Addendum 1
Solicitation 23-99641
Shoreline Rehabilitation between 3rd Ave. E and 4th Ave. E.

This addendum serves to notify all bidders of the following changes to the solicitation documents:

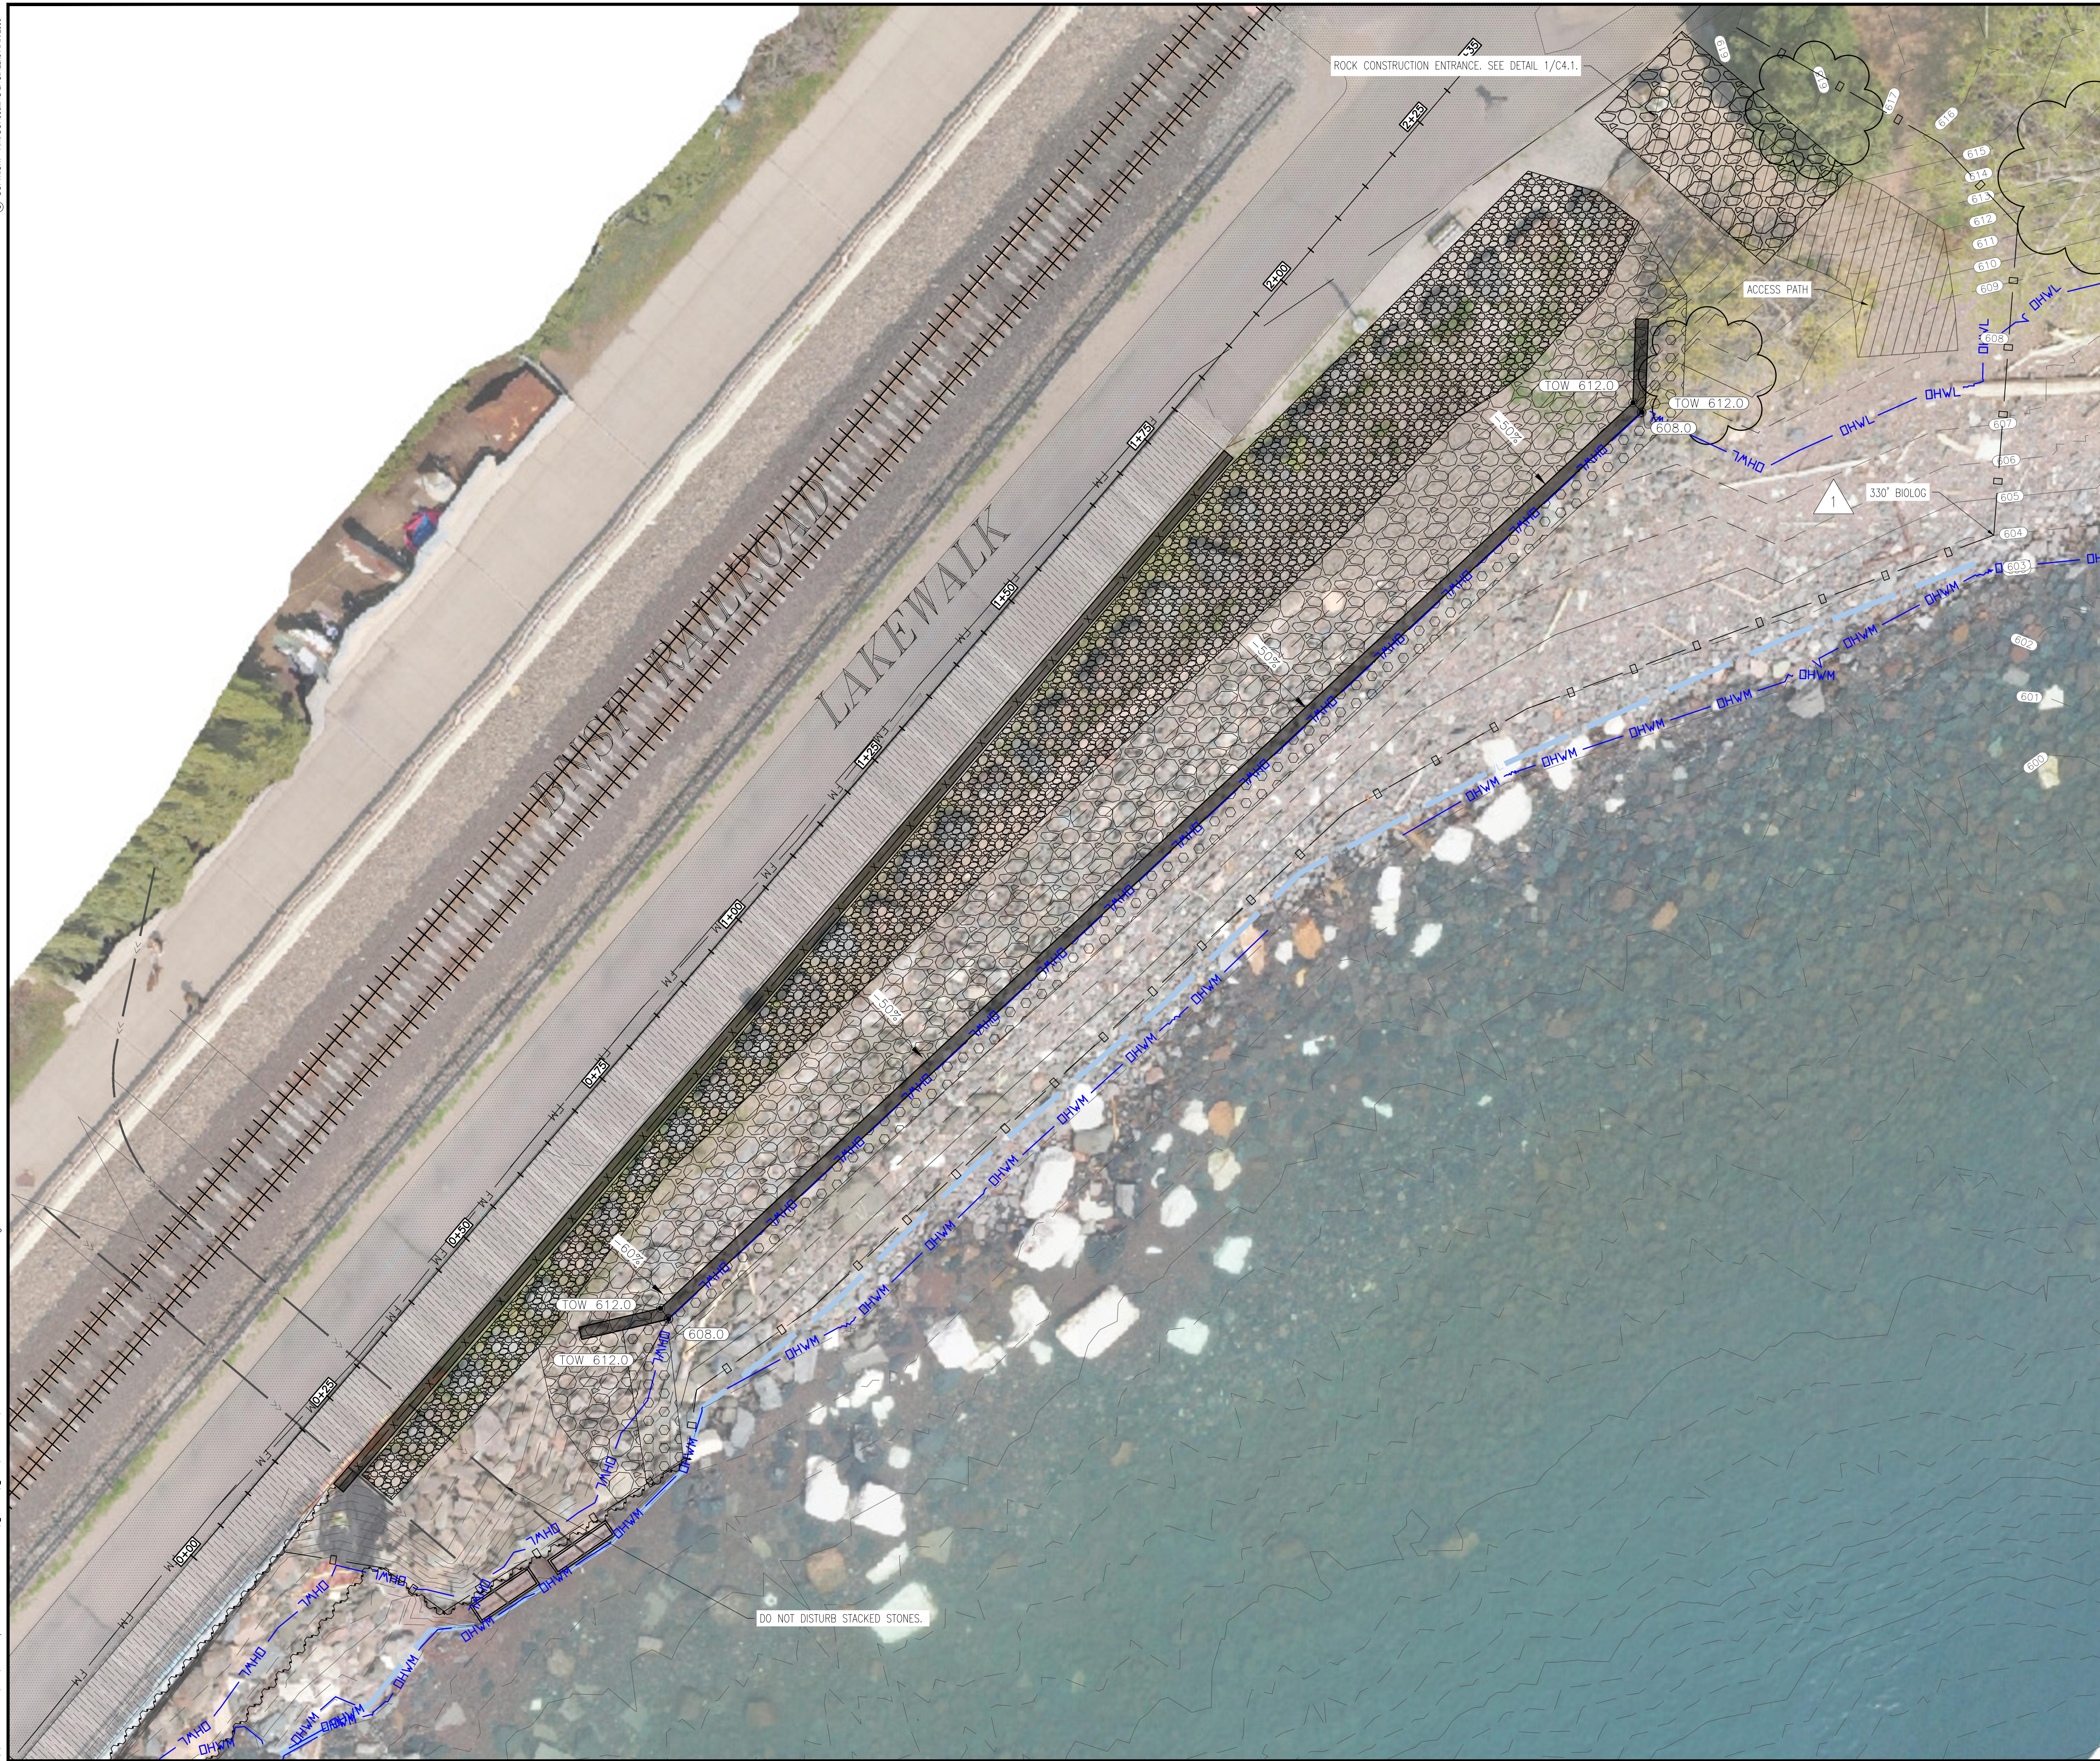
- Plan Sheets C4.0 and C4.1 have been updated to remove the temporary rock windrow from the plan set. This does not alleviate the Contractor from protecting the site during storm events (wave, wind, rain, etc.). In the event a storm event arises, the Contractor will need to properly secure the site. A submittal will be required for the Contractor's approach on this after the notification of Award is issued. Contractor shall assume full responsibility for protecting the site for significant wave heights up to 12 ft in height as measured from NOAA Buoy 45028 (<https://www.ndbc.noaa.gov/>). NOAA Buoy 45028 is located offshore approximately 12.62 miles from the Site at a heading of 82.16 degrees. If buoy data is not available, the Contractor shall ensure that the Site is protected for constant wind speeds below 40 mph measured from the weather station FW0850 in Duluth, MN (<https://www.sailflow.com/spot/170527>).
